CITY PLAN COMMISSION STAFF REPORT

Barrio Major Amendment

CD-CPC-2024-00003

Rezoning to UR – Major Amendment

SOL CANTINA
 408 E 31 STREET
 KANSAS CITY, MISSOURI 64108
 BUILDING ELEVATION

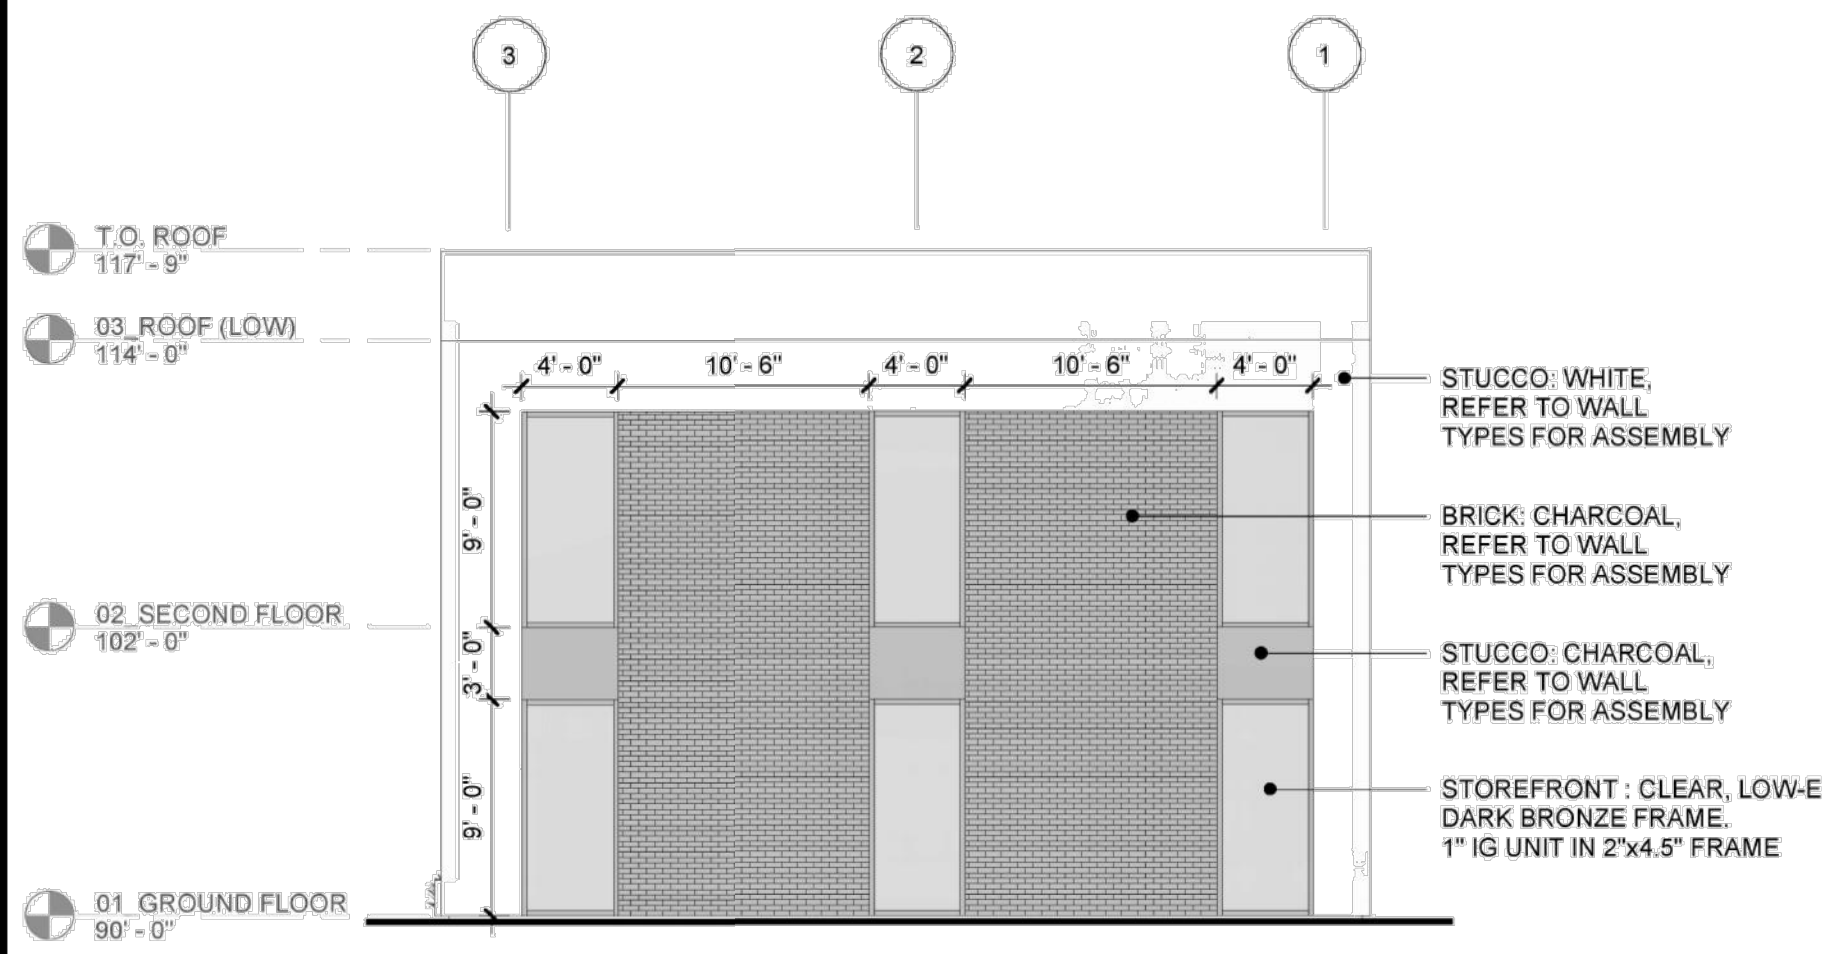
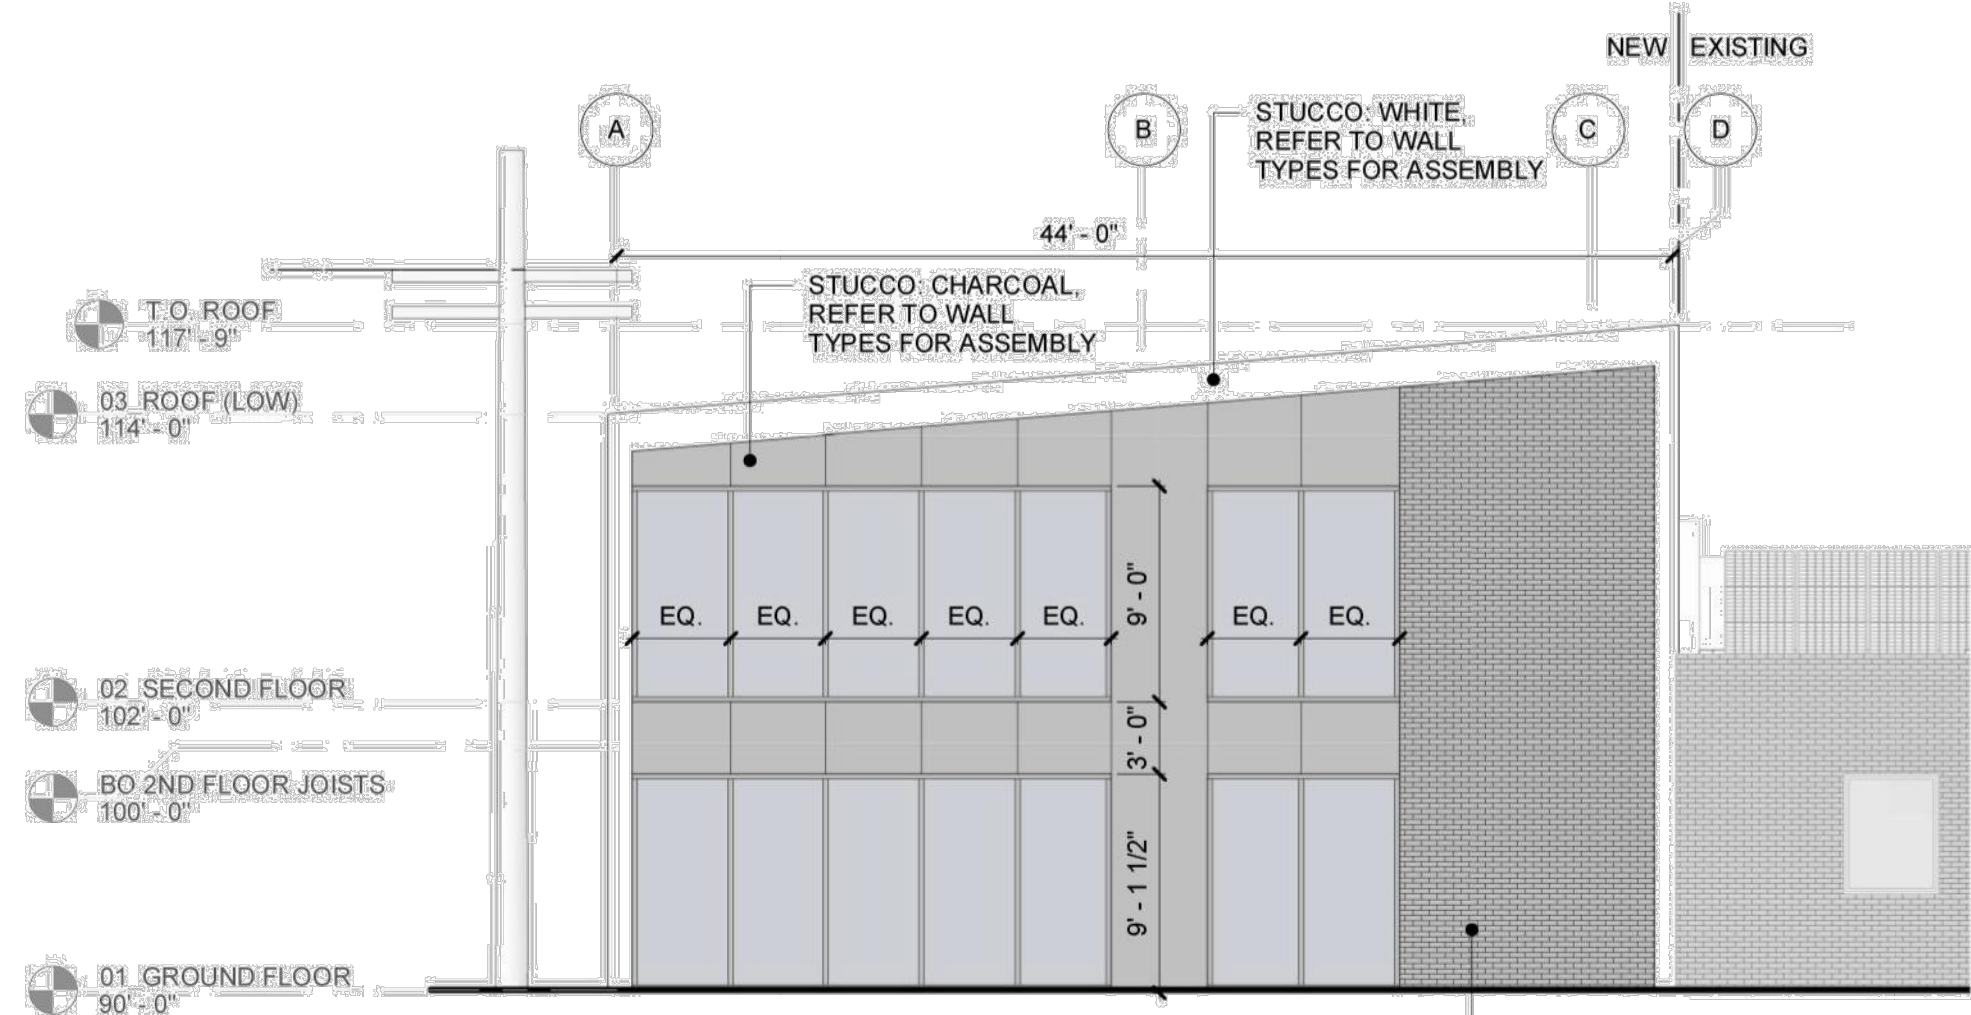
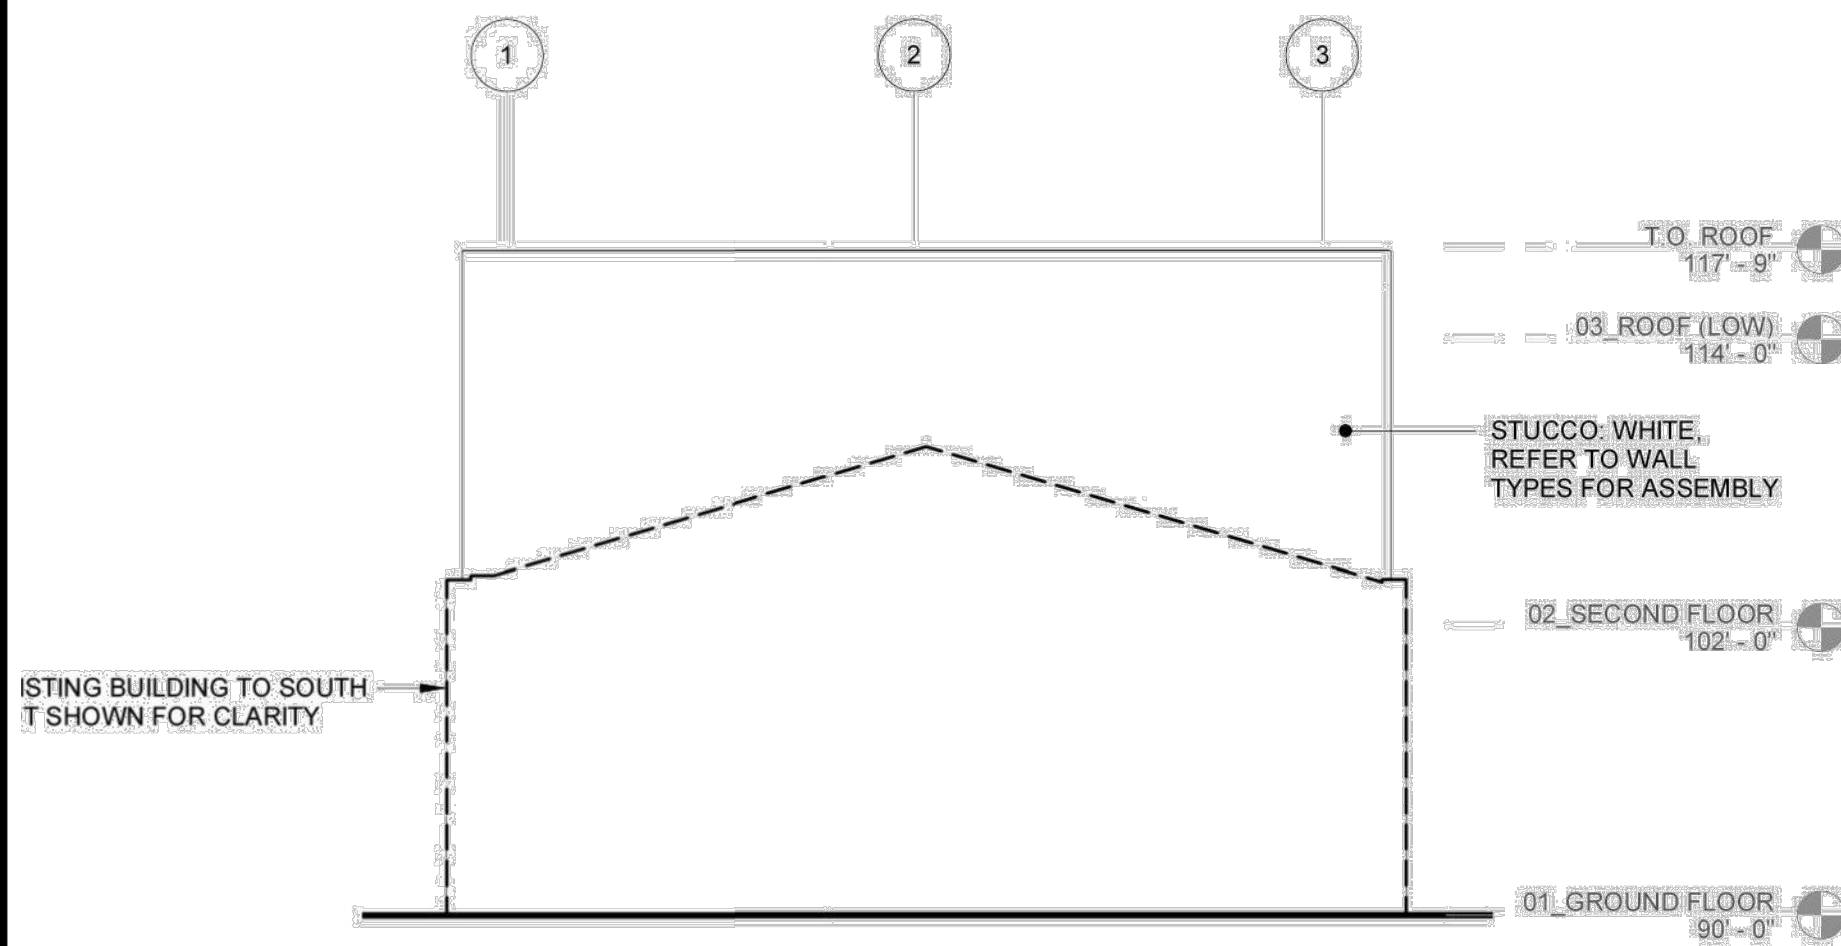
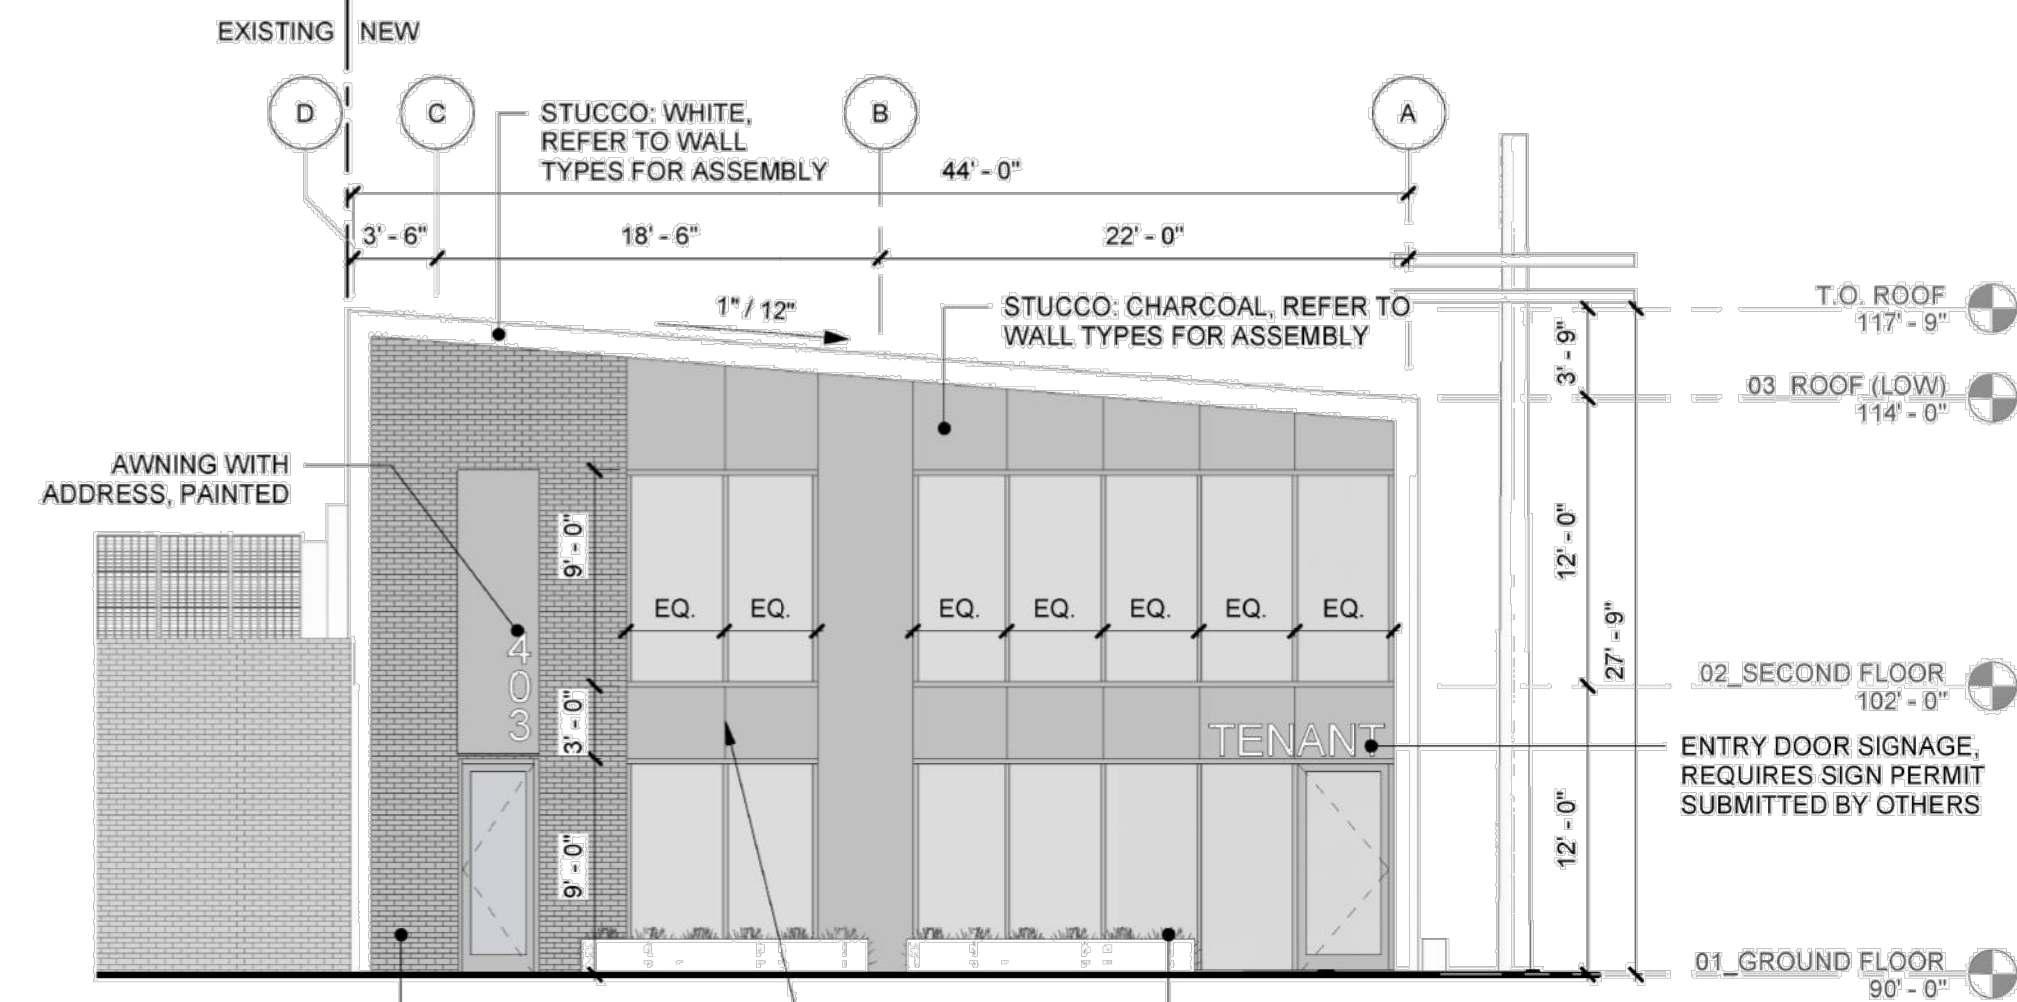
“As infill development, the project meets KC Spirit Playbook guidelines for effectively using existing infrastructure. While the painted stucco deviates from the earth-tone brick nature of the district, I am satisfied that it will not stand out too greatly.” – Luke Ranker

The proposed building materials include stucco and brick. These are compatible with the existing buildings in the area.

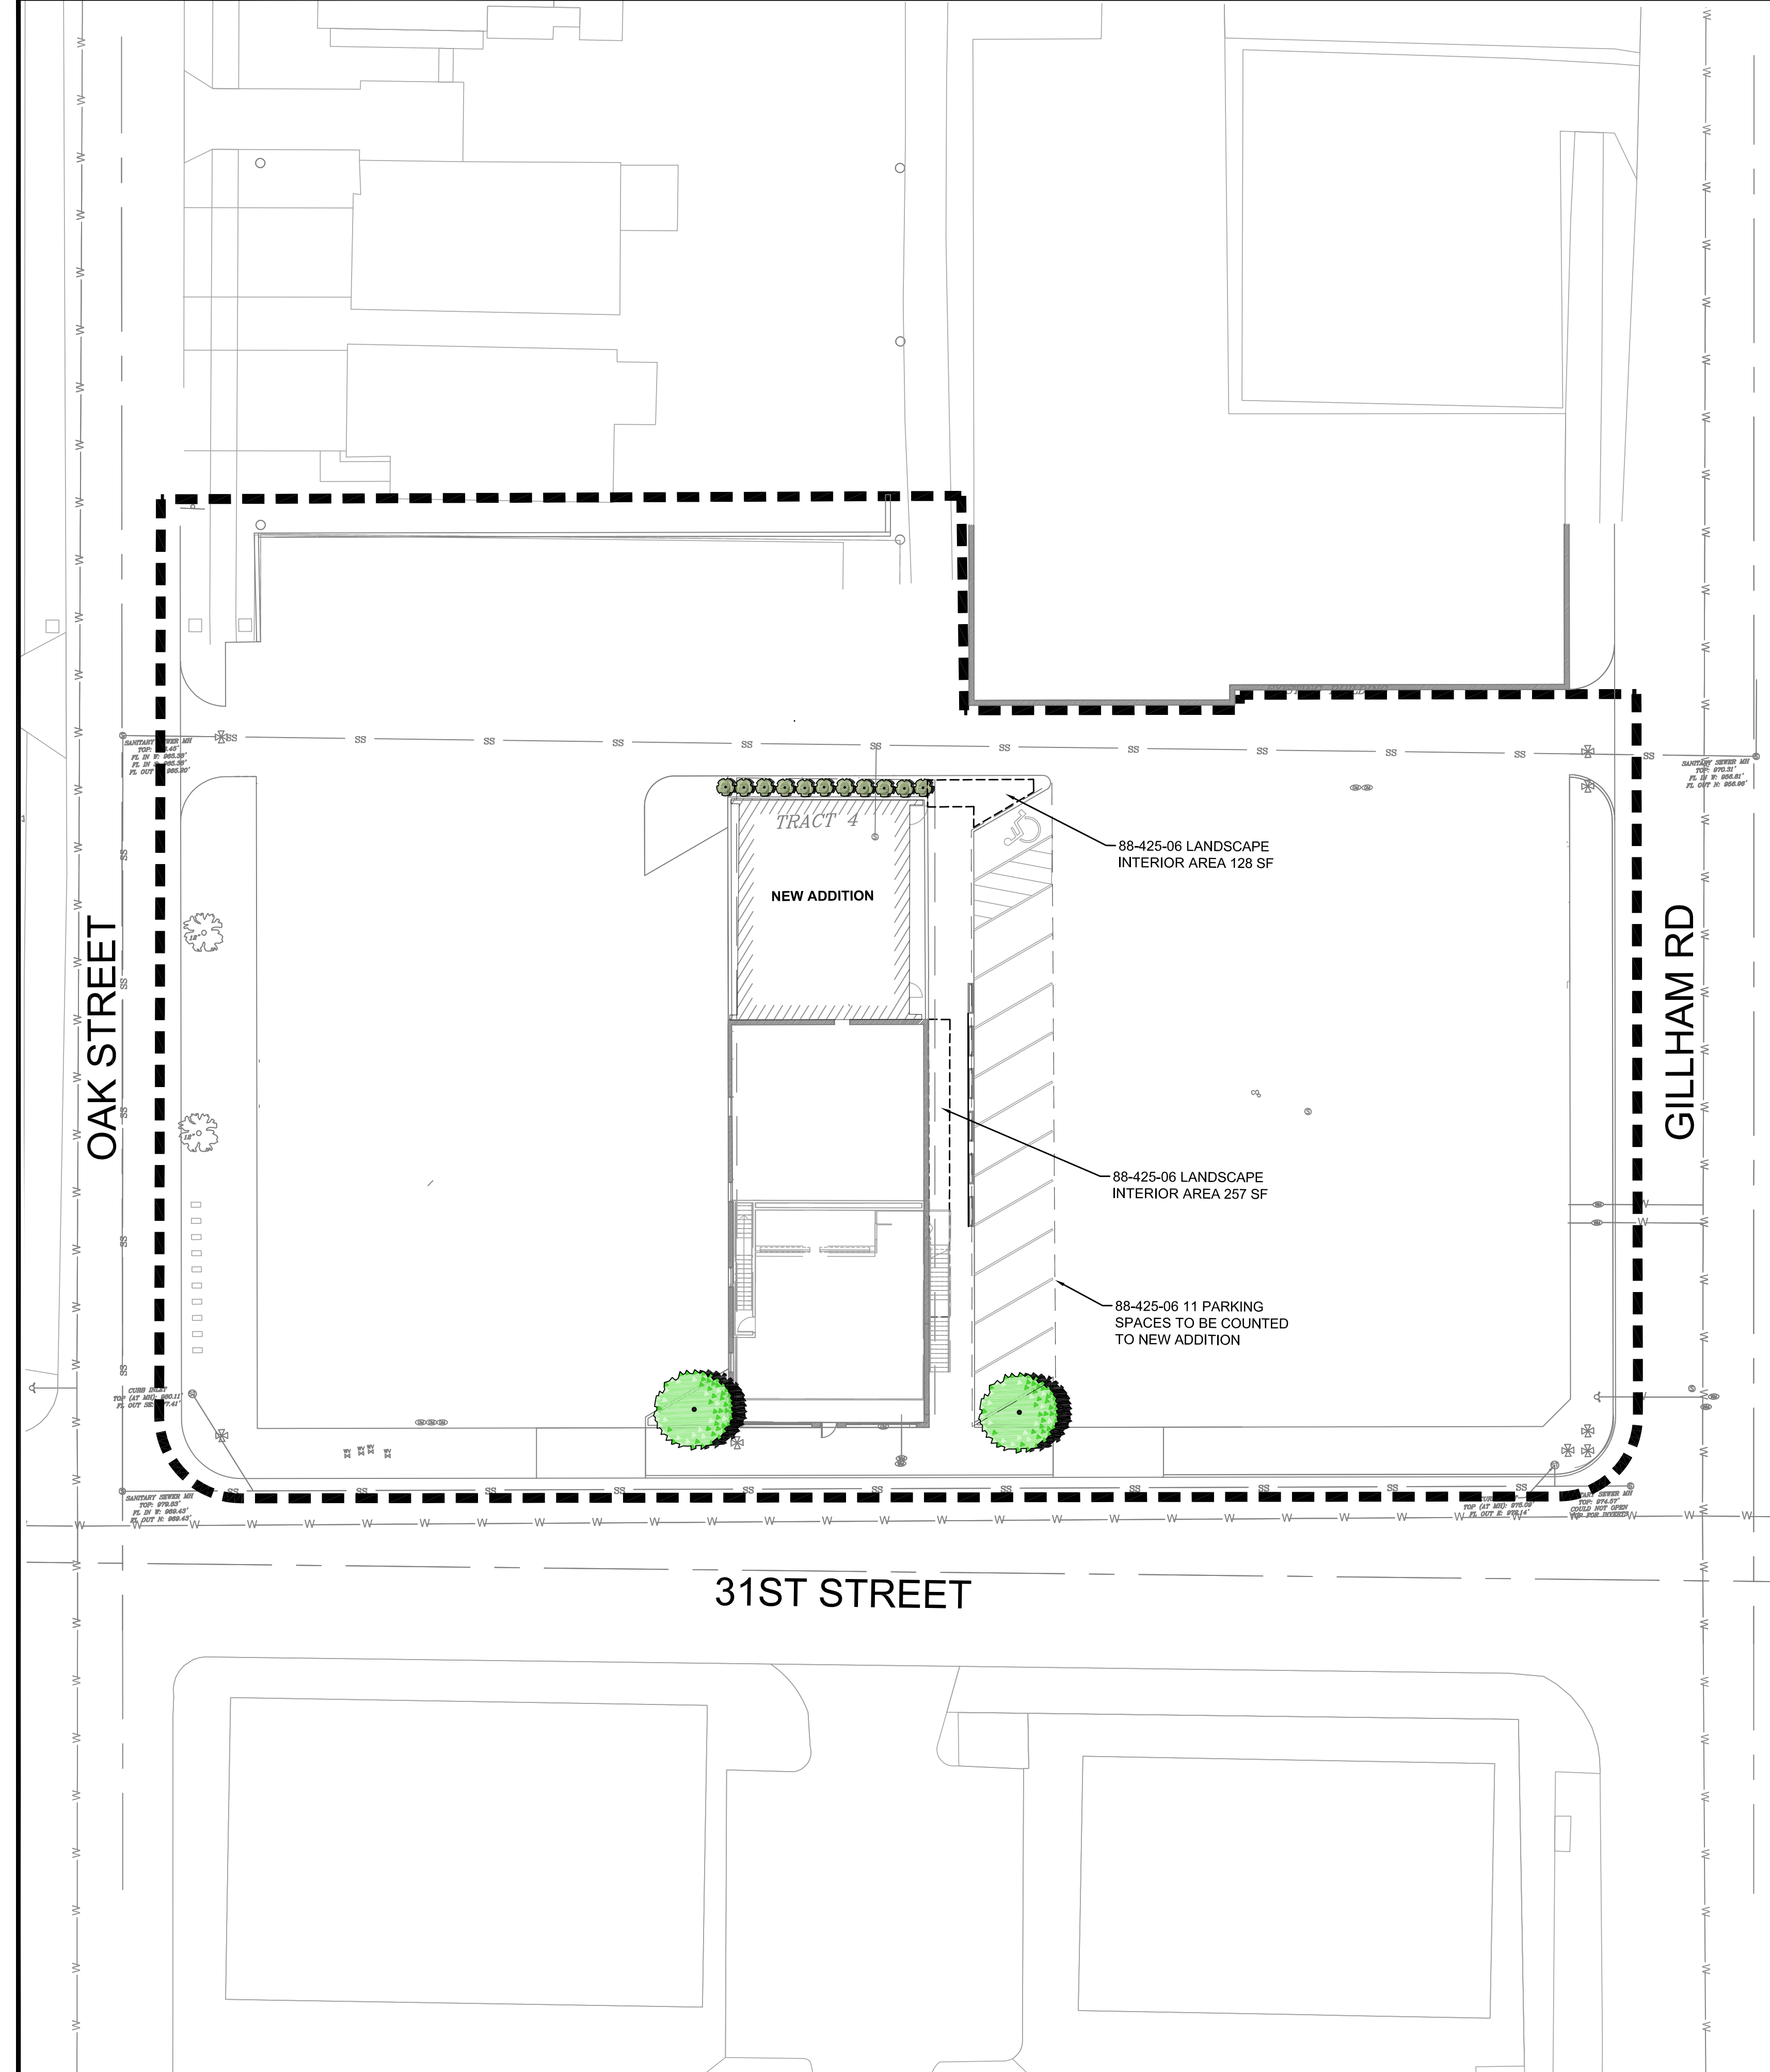
The landscaping plan shows one street tree is required; however, due to existing conditions of the site, the owner cannot install the tree, therefore, they are paying a fee in lieu. Other landscaping will be mostly included in planters due to the existing conditions of the site, as well as two trees in the parking lot. Proposed species include red maple, Oklahoma Redbud, Ninebark, and Boxwood.

There will be minimal landscaping on-site, as the buildings are zero setback on most of the property lines. The plans show planters, two trees in the parking lot, and shrubs on the north side of the new building.

13. The developer shall pay into the Street Tree fund in lieu of planting. A fee of \$370 will be due prior to Certificate of Occupancy.
